Product/Process Change Notice - PCN 23_0136 Rev. -

PCN Title:	LTC7878 Data Sheet Change
Publication Date:	15-Aug-2023
Effectivity Date:	17-Nov-2023 <i>(the earliest date that a customer could expect to receive changed material)</i>
Revision Description:	Initial Release.

Minor changes to the LTC7878 product datasheet as shown on the attached pages of the marked-up datasheet.

BLOCK DIAGRAM

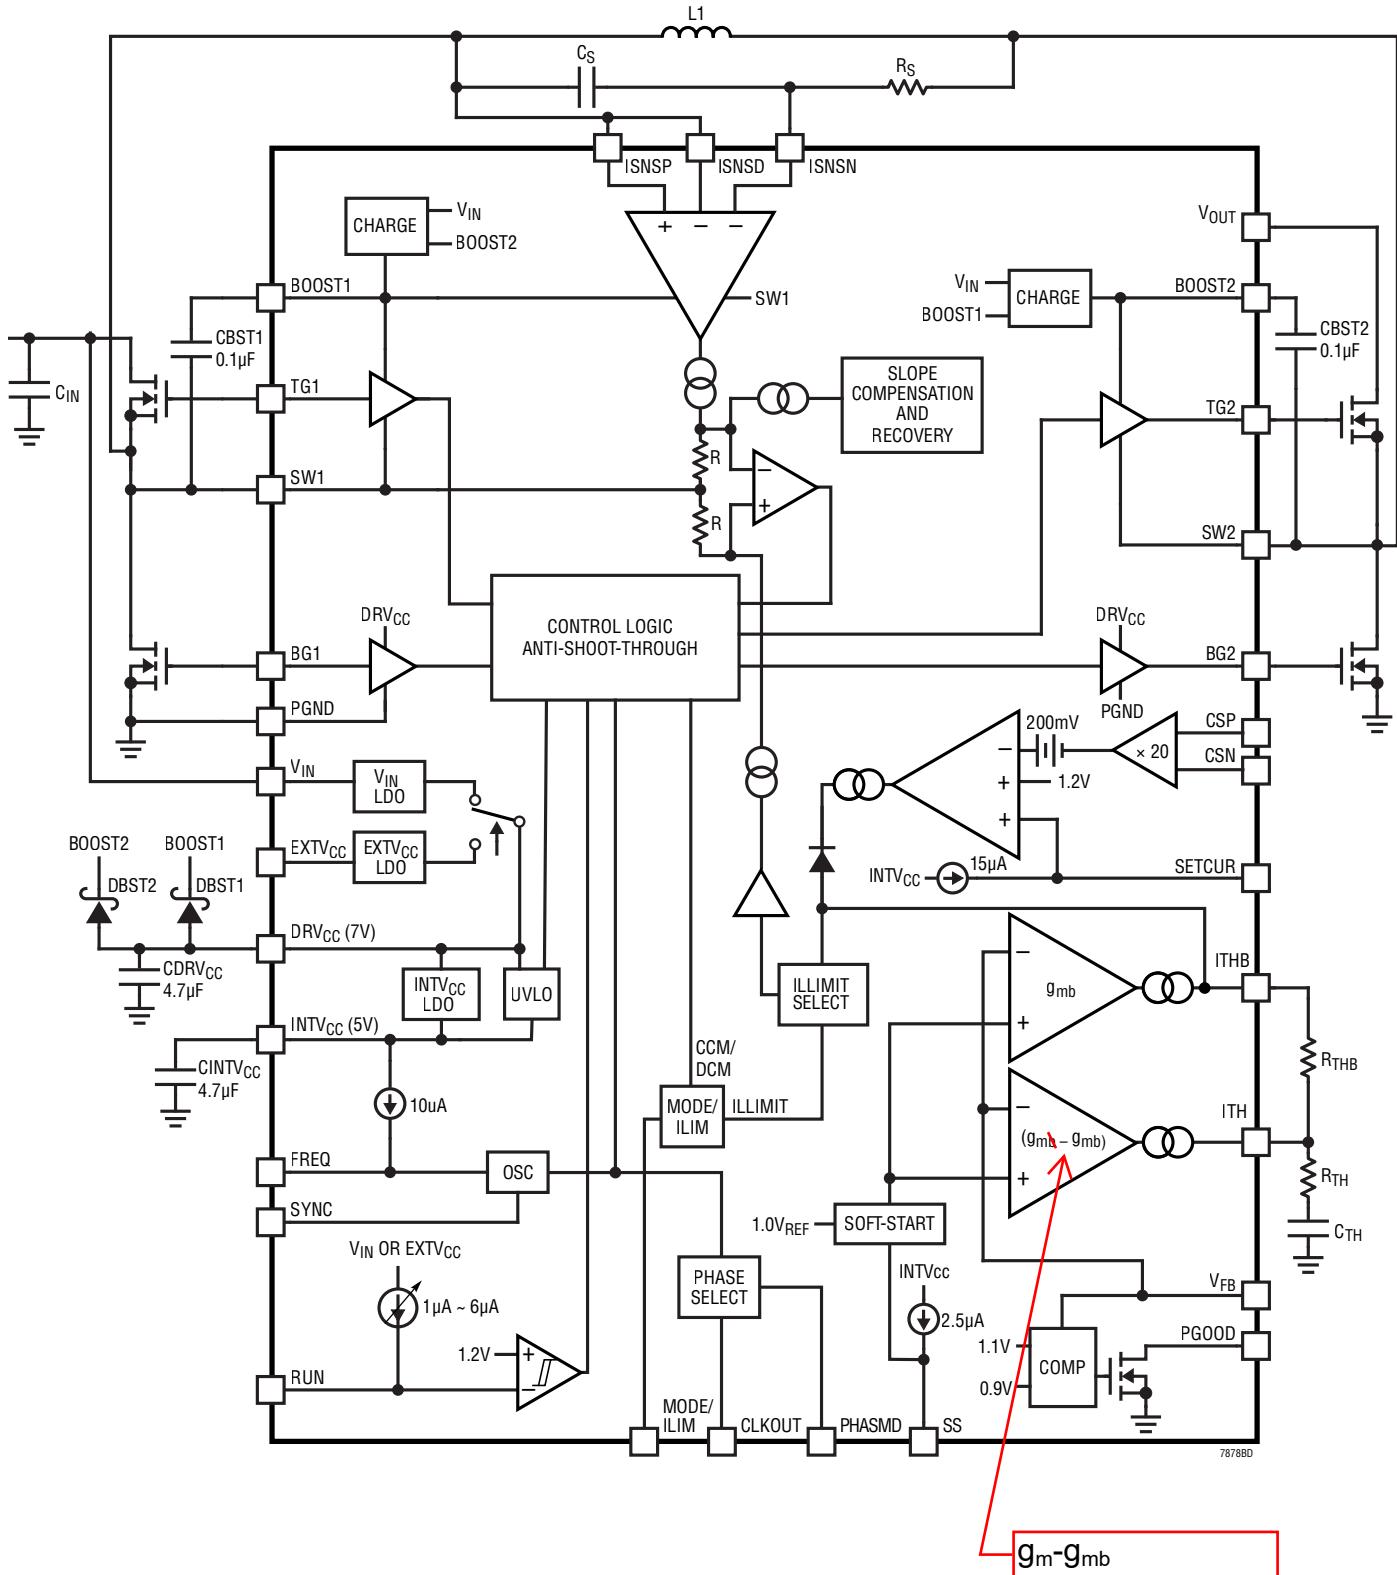
1. Electrical Characteristics table changes (page 3 of datasheet):
DRVcc Under Voltage Lockout: Change upper limit from 4.5V to 4.62V.
2. Block Diagram (page 10 of the datasheet):
Change (gmb - gmb) to (gm-gmb)
3. Change Iload formula on page 15
4. Application Information (page 19 of datasheet):
Change DBST1 to DBST2
